Proposed residential care facility Floribunda Avenue Glenmore Park

- 1 This report evaluates urban design quality of the amended architectural concept which is dated 12 April 2019:
 - i Those plans superceded the original concept which was dated 21 February 2019, and they were provided following discussions with the UDRP on 20 March.

Penrith UDRP - Brett Newbold - May 201

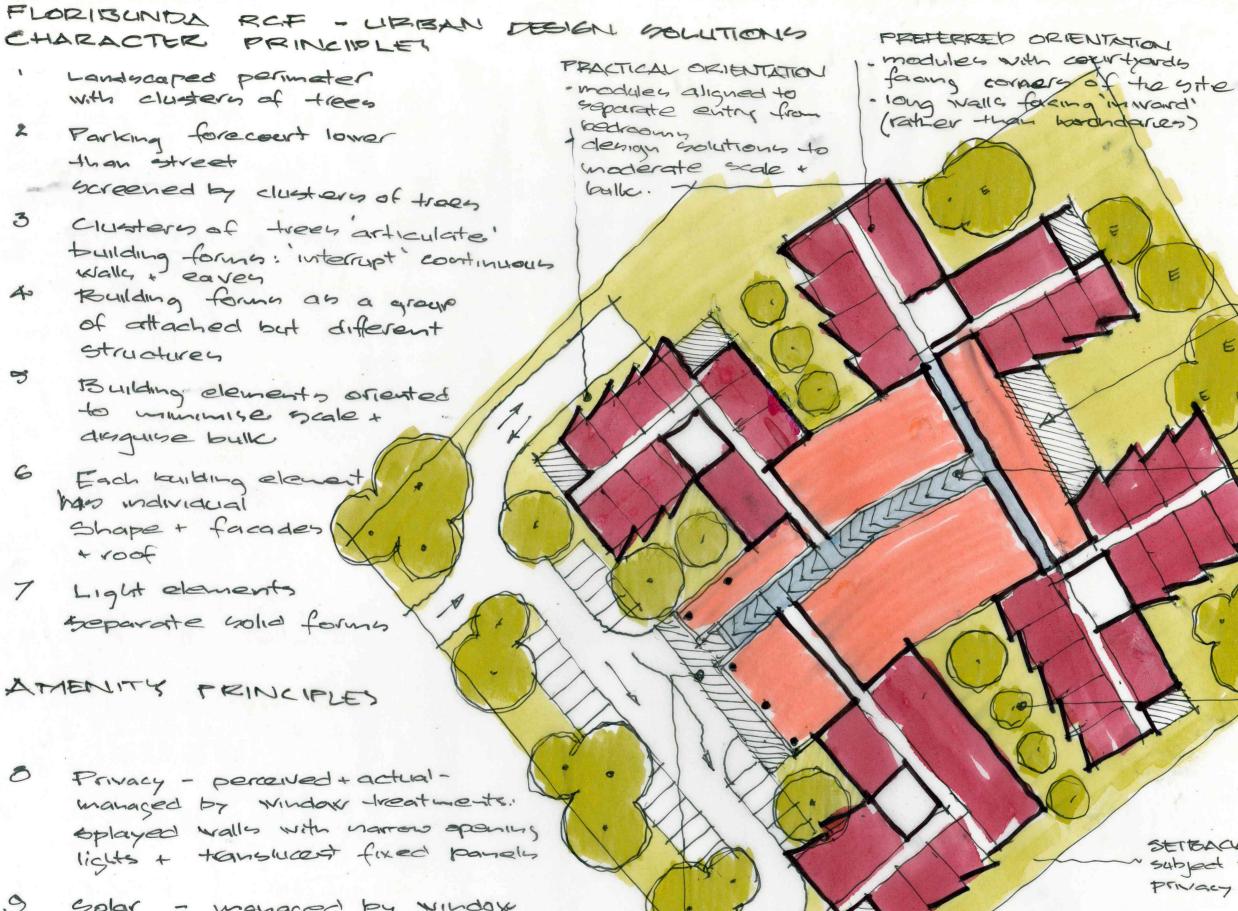
9 Golar - managed by window treatment : west-facing screened

> GLAZED CONTRAST: enty, allied health + admin as curtain shall elements with flat roof on columns

Biett Newbold 1305 10 REAR 25%. Single storey GENTLE RAMPS to lower the northern Wings COURTYORDS signature landucaped fatures visible for all common aveast collidors SETBACKS subject to landscaping t privacy (perceived). STEEET SETBACK primarily landsaped or appearance of landscaping - parking as appropriate LANDSCAPING of - street corners " clusters of trees
